CS-21-02-01 - Pines Point Cabinet Project

CS-21-02-01 “Pines Point Cabinet Project”

To assist bidders, the City is providing this document, which contains a summary of the General Scope of Work, and related information that was originally included in **RFQ # CS-21-02** **“Kitchen & Bathroom Cabinet Fabrication & Installation for the Housing Division.”**

INTERIOR ELEVATION SCALE 1/4"=1'-0"

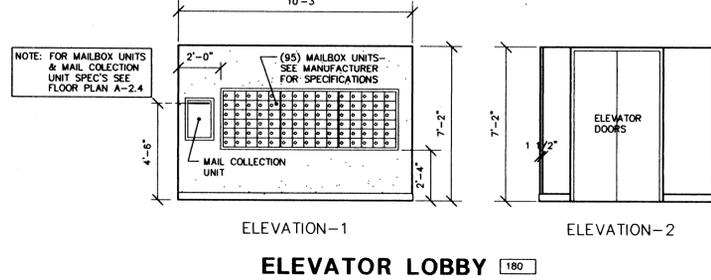
Question # 2	<p>Drawings of Pines Point Residences shows that the Kitchen Upper Cabinets Doors goes to the ceiling, however on site the visit we saw doors with a big valance on top; please confirm which design we need to follow.</p>

Answer	<p>There is a valance that will remain in place. The new cabinets will butt to the existing valance. The valance will need to be resurfaced with color matched (cabinet color) Formica.</p>

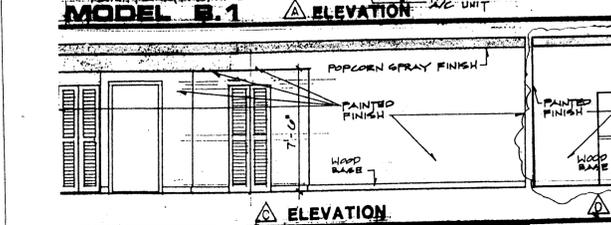
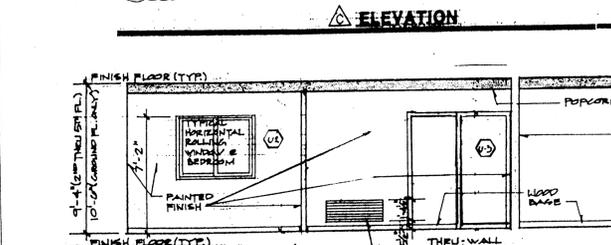
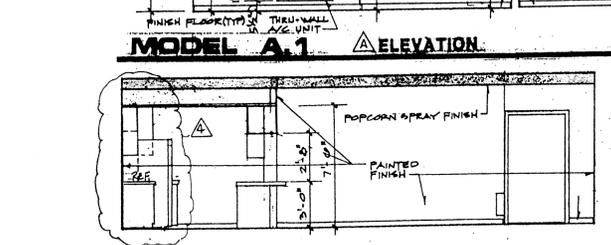
Item 3. Addendum No. 2 - Rebid Documents
 Revise Residential Appliances
 Void residential appliance list shown in Sheet A-2.6 and supplant with the following: (#16)

- VOID APPLIANCE LIST**
 (100 Apt. Units)
- MEF H 520 - 300
 - FRT 18 DFC
 - MMX 12
 - MDE 216
- * OWNER REQUEST ***
- 30" Range
 - 24" Range Vent Hood
 - 18 CF Refrigerator with Freezer
 - Washing Machine
 - Clothes Dryer
 - include Range & Dryer Power Cords
 - 18" DISHWASHER

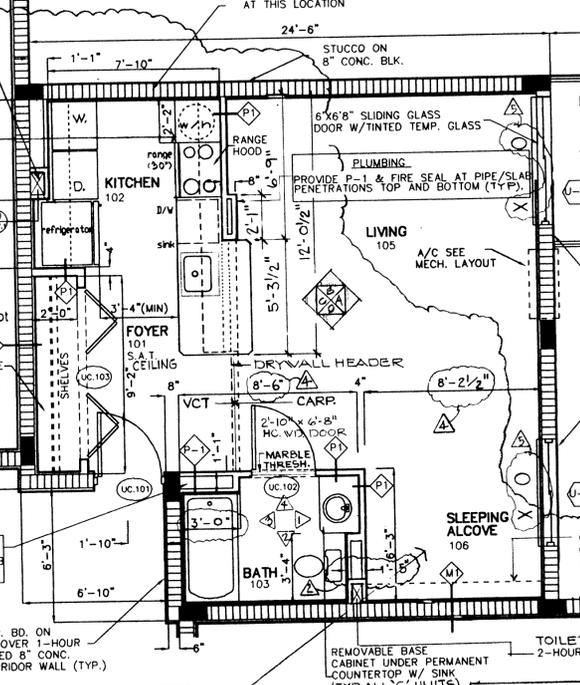
Item 13. Closet Shelving
 All shelving for A-1, B-1 and C apartment units shall be ventilated plastic-coated wire shelving systems as manufactured by "Closet Maid" or Architect approved alternate. Provide all accessories necessary for a complete and proper installation. Referencing Sheets A-2.6 and ALT-1.0, in closets, double (side by side) broken line symbol indicates 16" deep shelf with integral hanging rod; solid line with the word "shelves" indicates five (5) 12" deep shelves with metal support posts and all necessary accessories. Installation height of clothes rods shall be at 54" AFF. Clothes rods and shelving installation shall comply with Section 4.25.3 height of the Florida Accessibility Code for Building Construction, 1994 edition.

Shelves in Units B.1, within Door B103, shall be five tiers of 12" deep shelving. Shelves in Unit C storage closet shall be five tiers of 12" deep shelving.

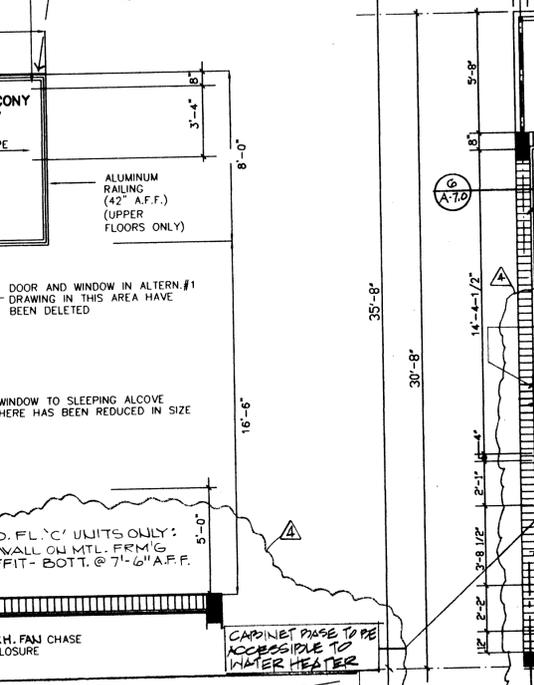
Item 48. Revise and Reduce Apartment 'C' Balcony to 5' x 8'
 Instead of 8' x 24'-6" balcony indicated in alternate one drawings, furnish 5' x 8' balcony. See revisions indicated in the cost reduction drawings for changes to all Apartment 'C' balconies.

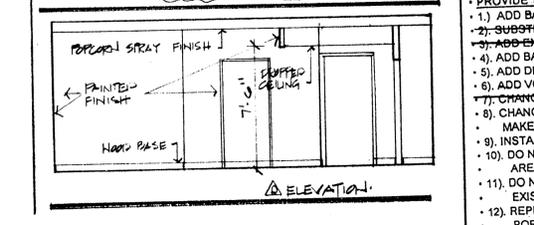
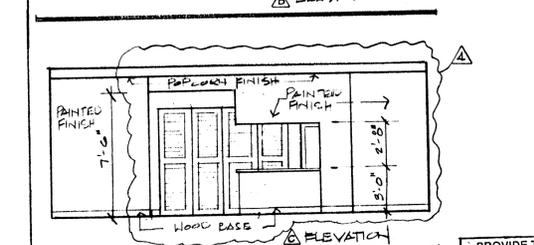
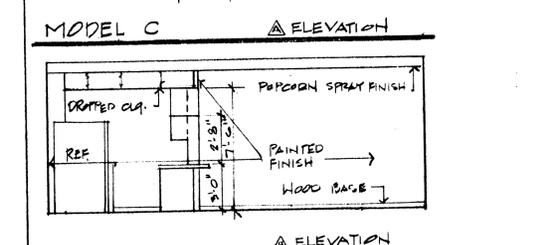
Item 60. Delete Apartment 'A' Pantry
 From all type A-1 apartments (60 units) delete storage cabinet (between entry door and refrigerator) and finish wall to match adjoining surfaces. See revised plans of apartments (copy attached). (#15)

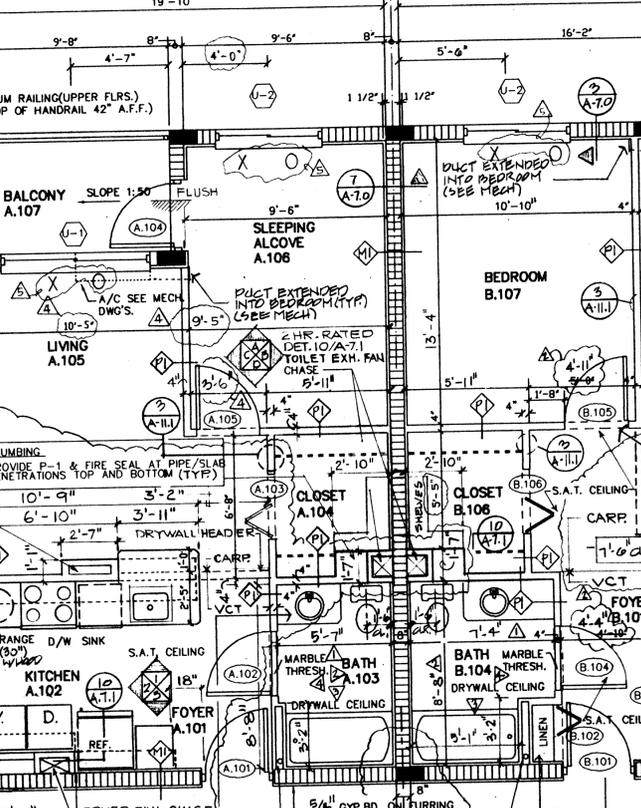
Item 42. Revise and Reduce Apartment 'B' Balcony to 5' x 8'
 Instead of 6'-4" x 12'-10" balcony, indicated in Sheet A-2.6 and throughout the Contract Documents, furnish 5' x 8' balcony. See revisions indicated in the cost reduction drawings for changes to all Apartment 'B' balconies. Note that in addition to reducing the size of the balconies, structural supports (columns, footings, beams, etc.), balcony railing, masonry openings, elevations, etc. have been revised. See "CR" drawings.

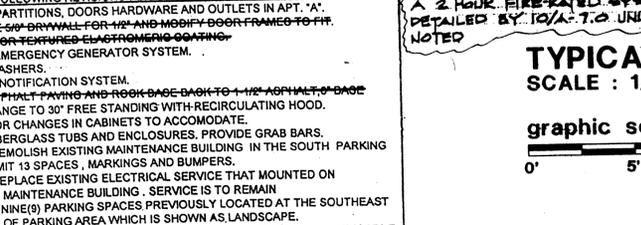
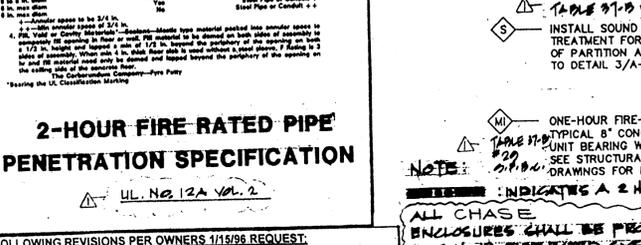
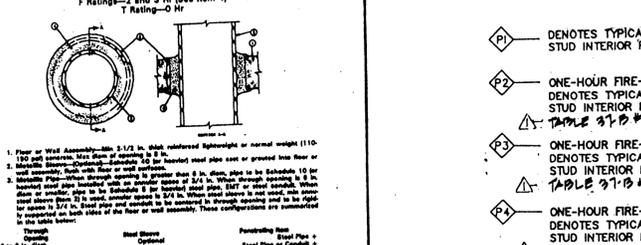
Item 53. Delete 7' of Partition in Apartment 'B'
 Reference cost reduction drawings for deletion of 7' long floor to slab portion of partition in all apartment type 'B' units, and relocated electrical switches, outlets and relocated door B-105 incidental to this change. (#133)
